- 4. Pavilion Subdivision Part 2 Amended 2026 Replat
KPB File 2026-004
McLane Consulting Group / Heintz
Location: Marlyss Circle
Ridgeway Area**

**ITEM #4 - PRELIMINARY PLAT
PAVILION SUBDIVISION PART 2 AMENDED 2026 REPLAT**

KPB File No.	2026-004
Plat Committee Meeting:	February 9, 2026
Applicant / Owner:	Julie and Jason Heintz of Soldotna, Alaska
Surveyor:	Andrew Hamilton, McLane Consulting Inc.
General Location:	Marlyss Circle off Mackey Lake Road / Sterling

Specific Request / Scope of Subdivision: The proposed plat will combine two lots into one lot of size 2.196 acres and in the process will be finalizing a petition to vacate a platted utility easement.

PAVILION SUBDIVISION PART 2 AMENDED 2026 REPLAT
 REPLAT OF LOT 88 AND 318 PAVILION SUBDIVISION PART 2 AMENDED 1984-141

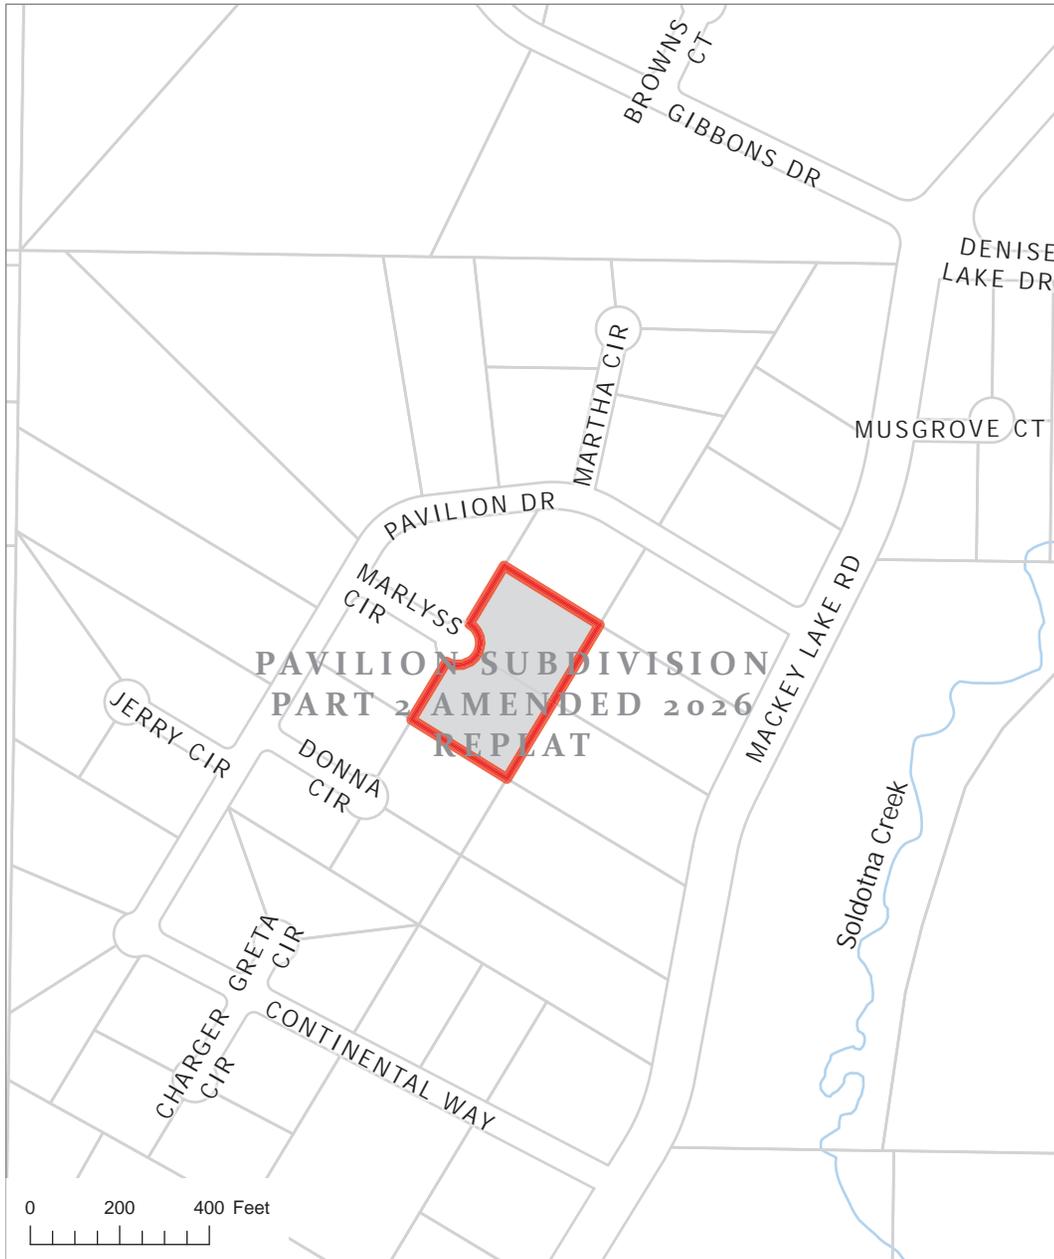
All easement of record ae depicted. The easement in the certificate to plat at item #9 needs to be added as a plat note.

Indicate a pin at both ends of C1.

- Add a plat note in reference to item 9 in the Certificate to Plat
- Add the CCRs as listed in the Certificate to Plat at item 12
- The borough will not enforce private covenants, easements, or deed restrictions per KPB 20.60.170(B).

Modify the KPB File No to 2026-004

Change plat name by removing 'Amended' from name, gives the idea this is an amended plat.

Legal description of the parent plat is incorrect, needs corrected to 'Pavilion subdivision Part 2 Pavilion Park Estates Addition Amended'

Add the city limits of Soldotna to the map.

10' utility easement at rear of lot need to be identified as per KN76-15

10' utility easement being finalized for vacation along former lot line needs to be identified as per KN76-15

Lot to the north needs the lot label corrected to 8A

Lot label needs Block 2 added to it.
